UNITED STATES PATENT AND TRADEMARK OFFICE

APPLICATION NO.	FILING DATE	FIRST NAMED INVENTOR	ATTORNEY DOCKET NO.	CONFIRMATION NO.
09/830,830	02/28/2002	Solomon Flax	082845000000	3585

Office Action Summary

DETAILED ACTION

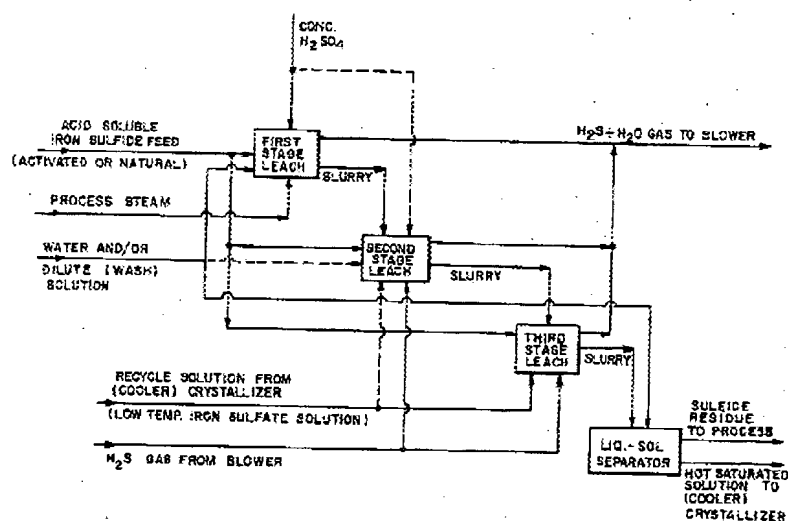
Claims 1 to 11 are rejected under 35 U.S.C. 112, second paragraph, as being indefinite for failing to particularly point out and distinctly claim the subject matter which applicant regards as the invention. The relationship of the claimed process steps to the flow-chart in the drawing is unclear. Claim 3 recites "precipitation of metal" but it is unclear the metal per se is being produced but rather metal sulfates. Applicants should explain where the claimed steps are located in the flow chart.
